PASADENA WATER AND POWER

SUBJECT: National Aeronautics and Space Administration (NASA), Jet Propulsion Laboratory (JPL) Technical Memorandum (TM): Additional Investigation Results, January 31, 2007

Review and Comments of NASA's Jet Propulsion Laboratory 31-Jan-07 Technical Memorandum: Additional Investigation Results

REVIEW AND COMMENTS OF NASA'S 31-JAN-07 JET PROPULSION LABORATORY TECHNICAL MEMORANDUM: ADDITIONAL INVESTIGATION RESULTS

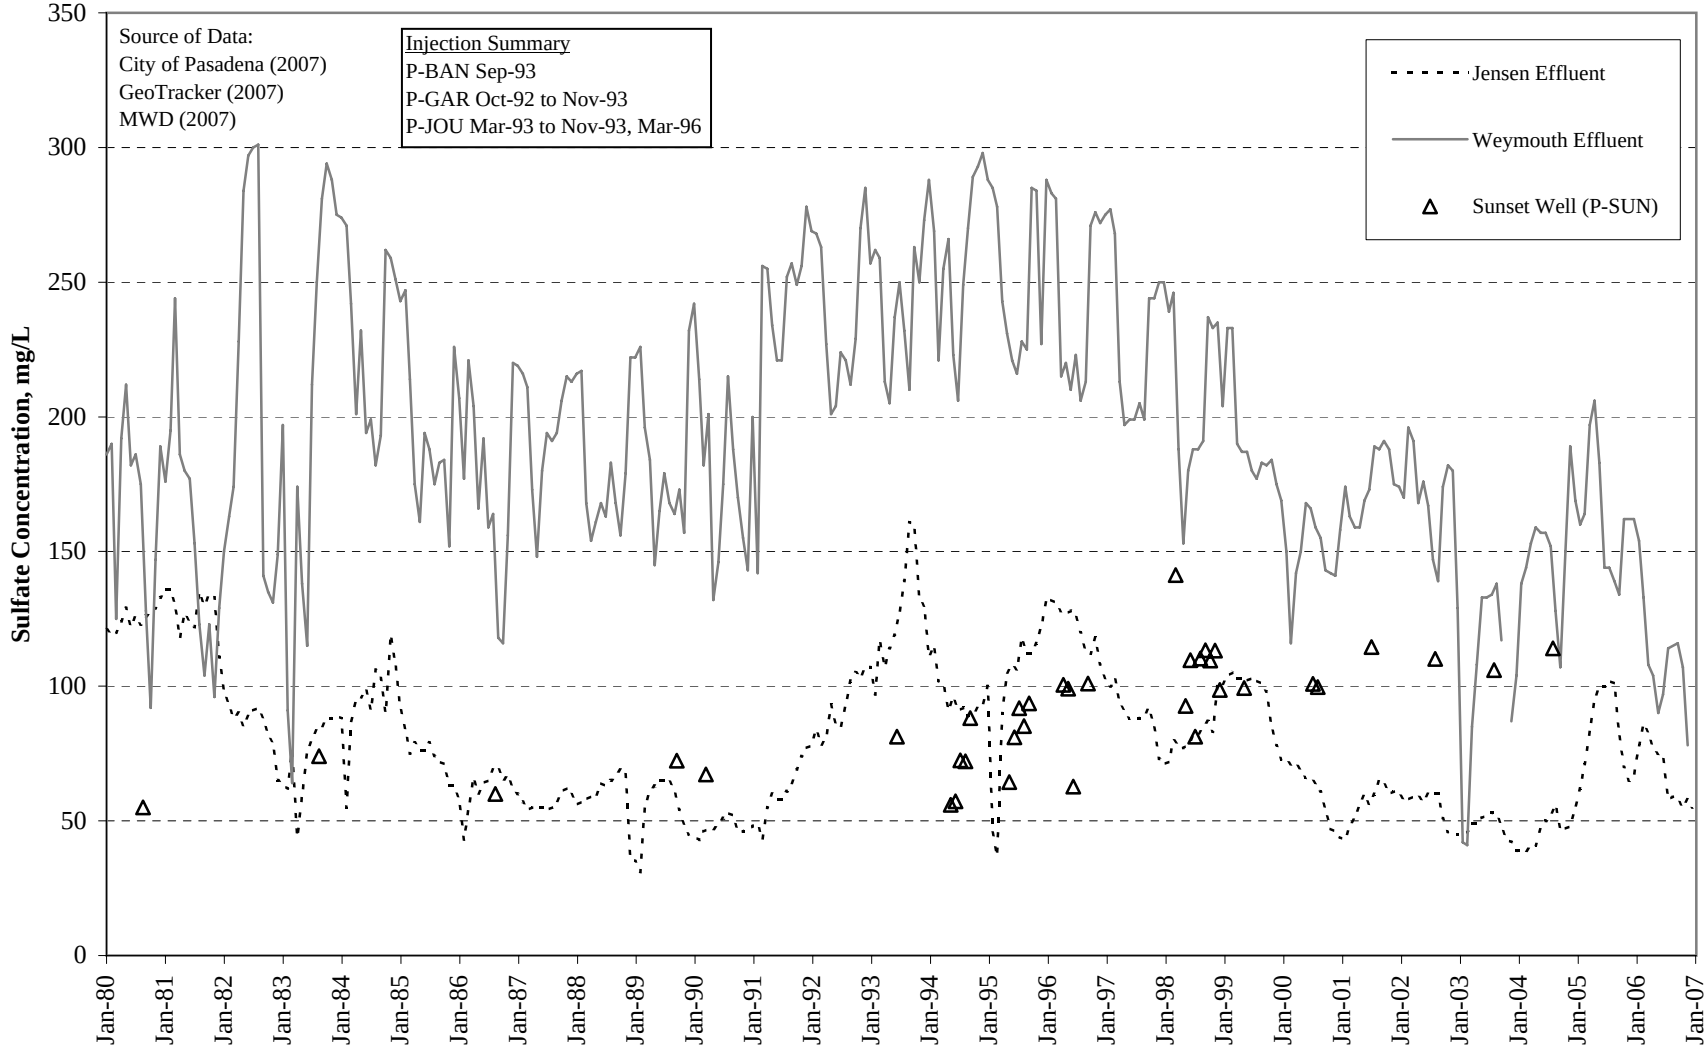
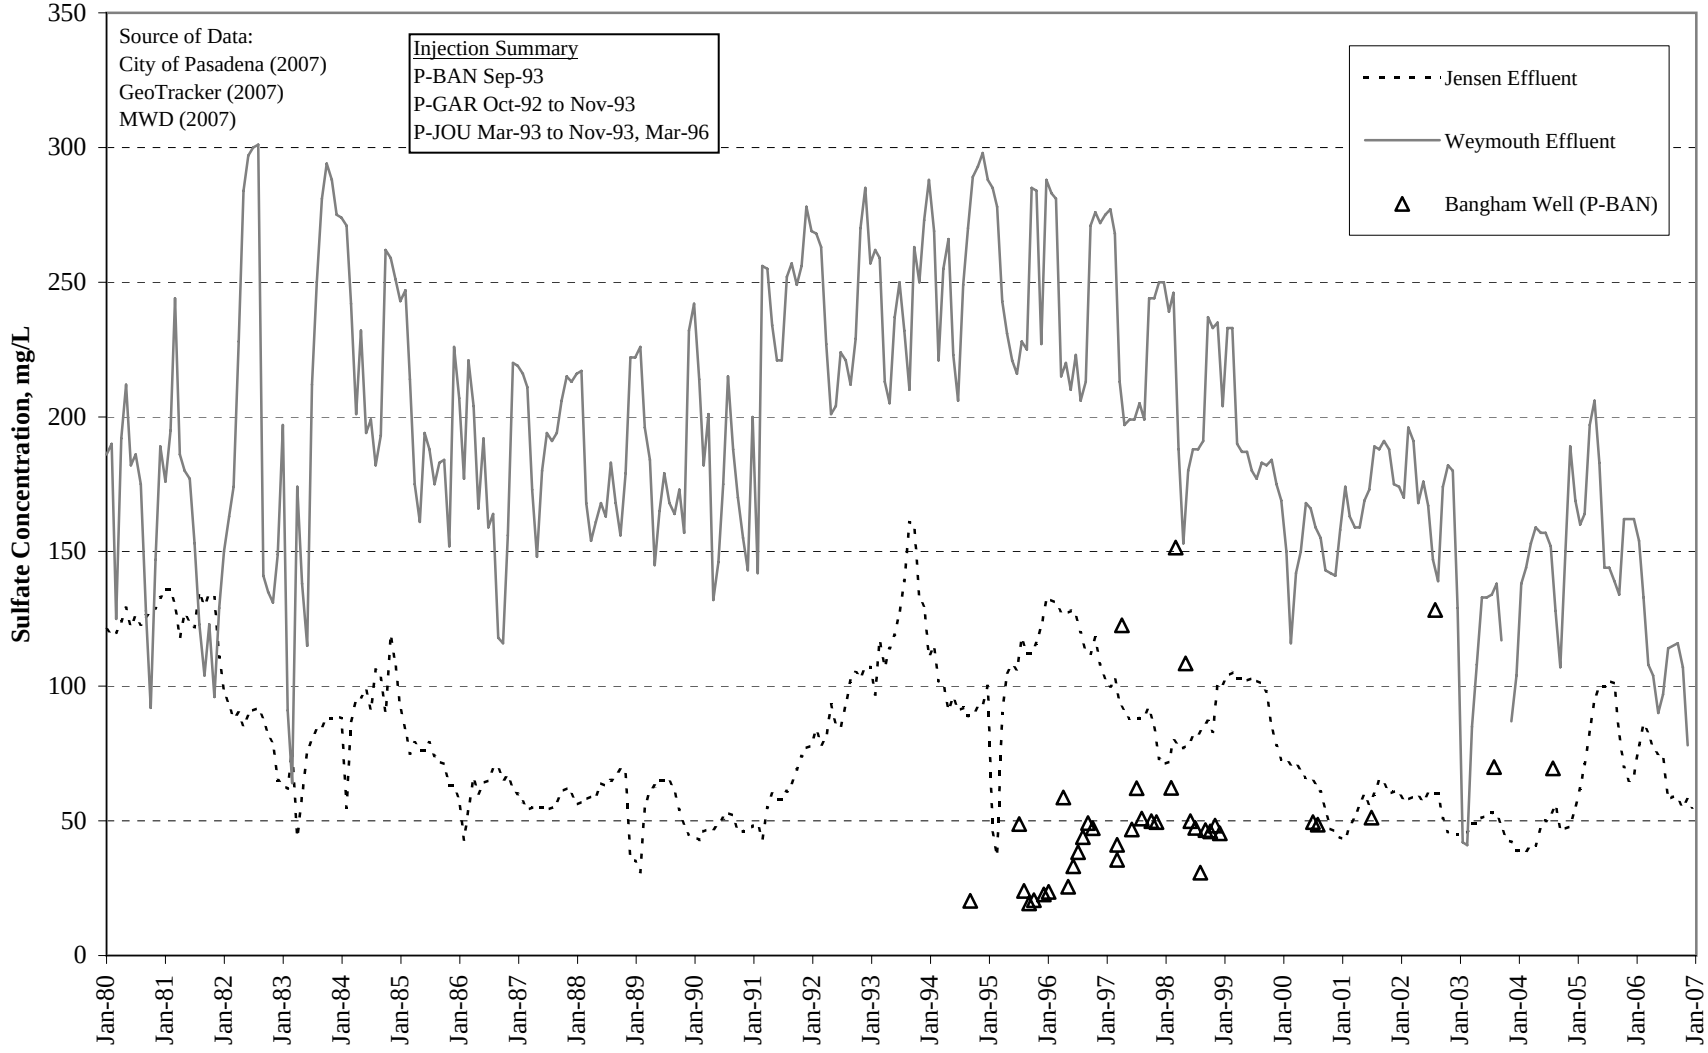
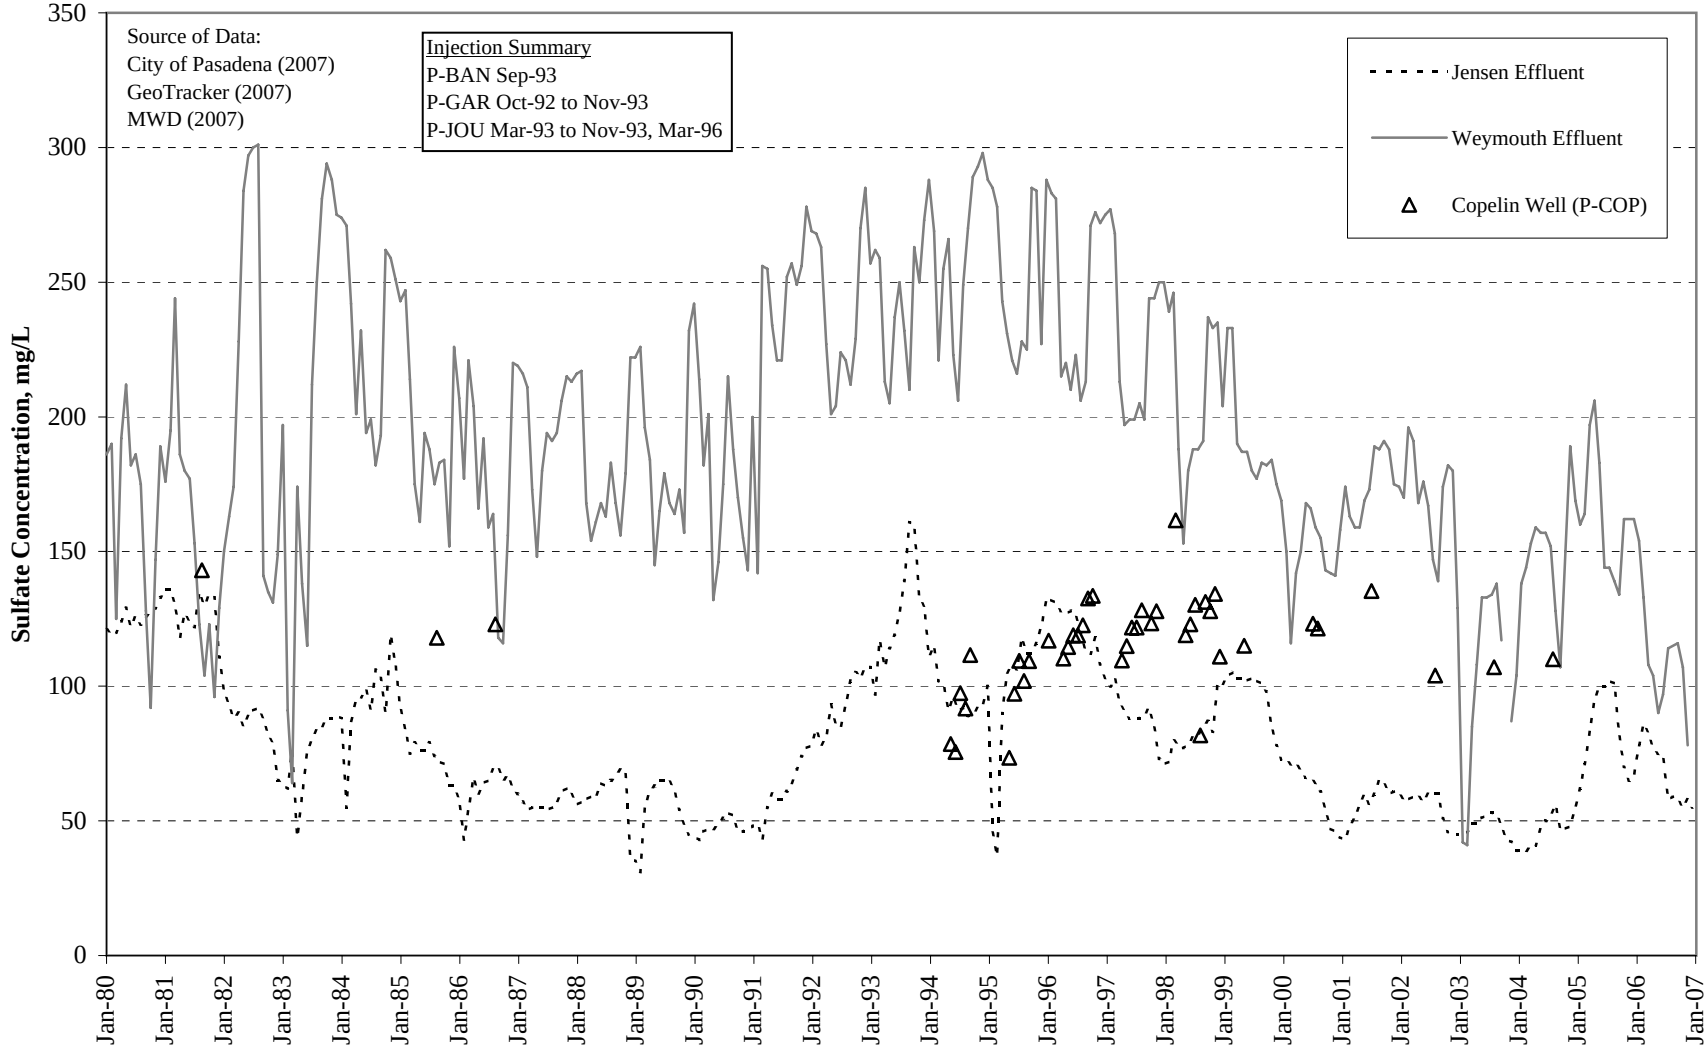
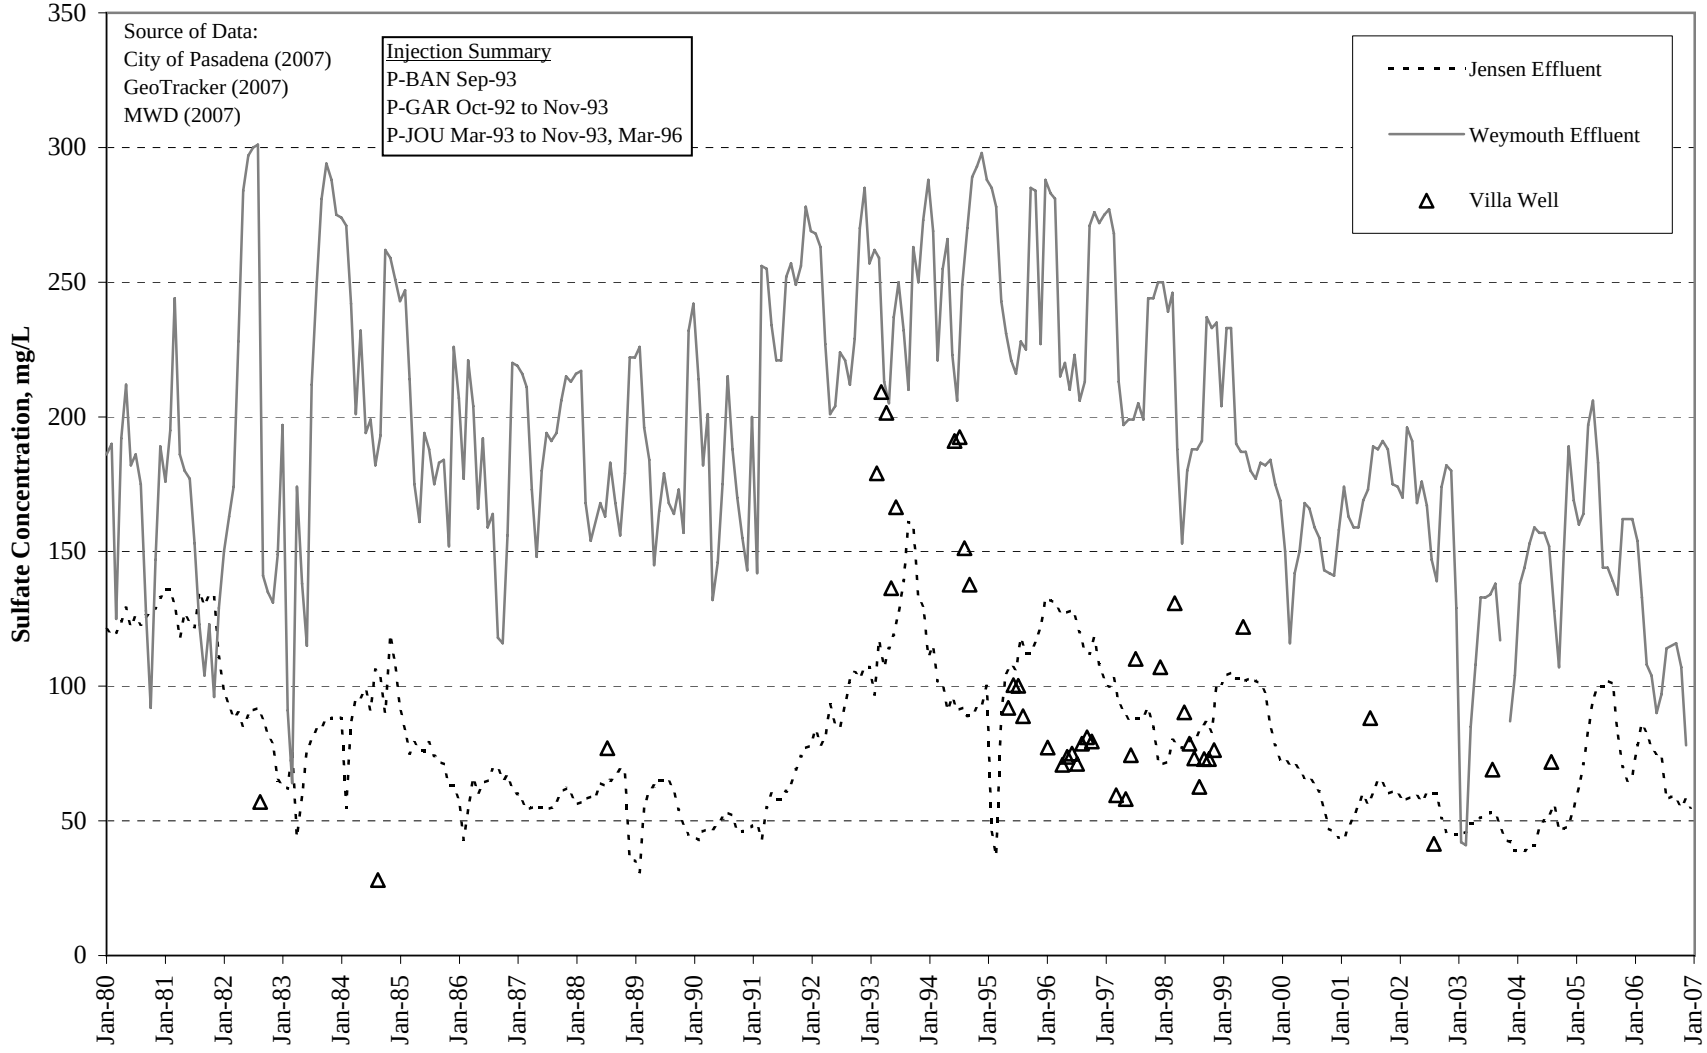
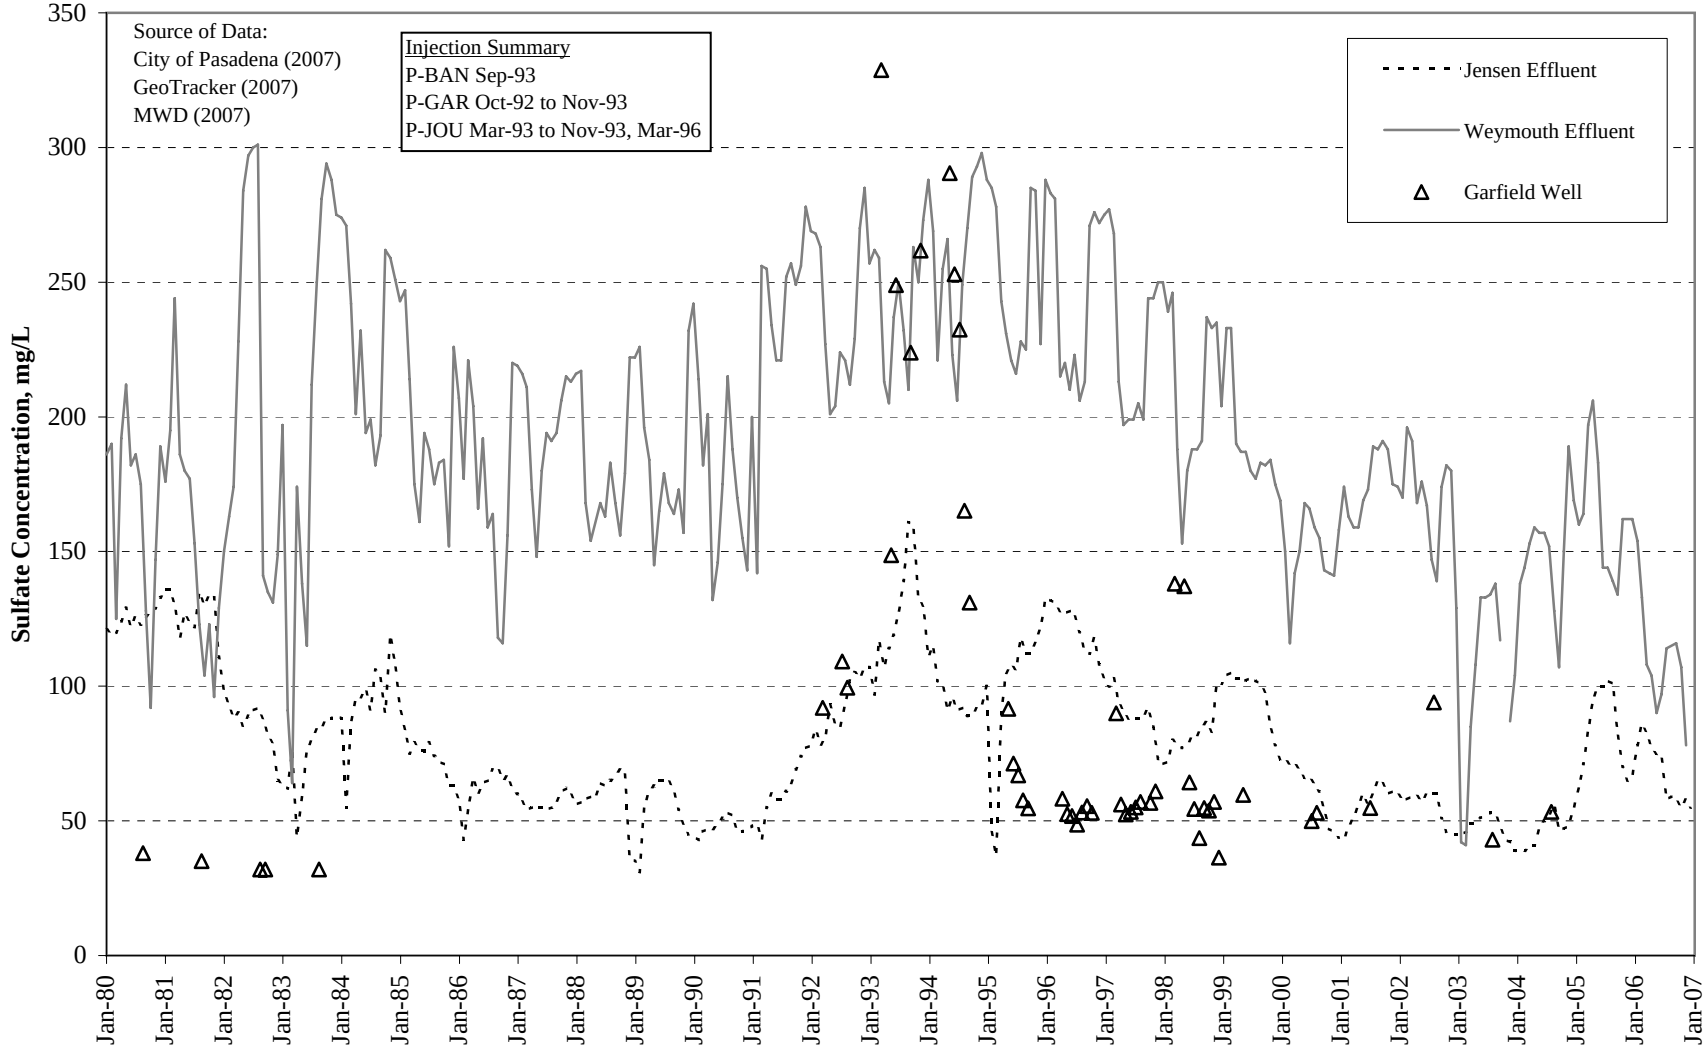
It is agreed that sulfate in the Basin has increased in some areas, possibly due to the importation of Colorado River Water and recharged as return flow including septic tank discharge in unsewered areas. Also, in the Sunset Reservoir and Valley Water Company wells, historical sulfate trends show a range of increases, no changes and decreases as shown in Figures 5 – 31, and summarized in Table 1.

If the mechanism described by NASA for concentrating perchlorate in the ground water to levels above the source/recharge water was valid, it would be expected that other salts, such as sulfate, chloride and TDS would also increase in the ground water to concentrations exceeding the recharge water. Figures 5 through 13 show that sulfate in ground water (both Sunset Reservoir area and Valley Water Company wells) have mostly remained at or below imported Colorado River and State Project water concentrations, while Figures 32 through 36 show perchlorate in ground water significantly higher than concentrations in imported water for wells hydraulically downgradient of the JPL facility.
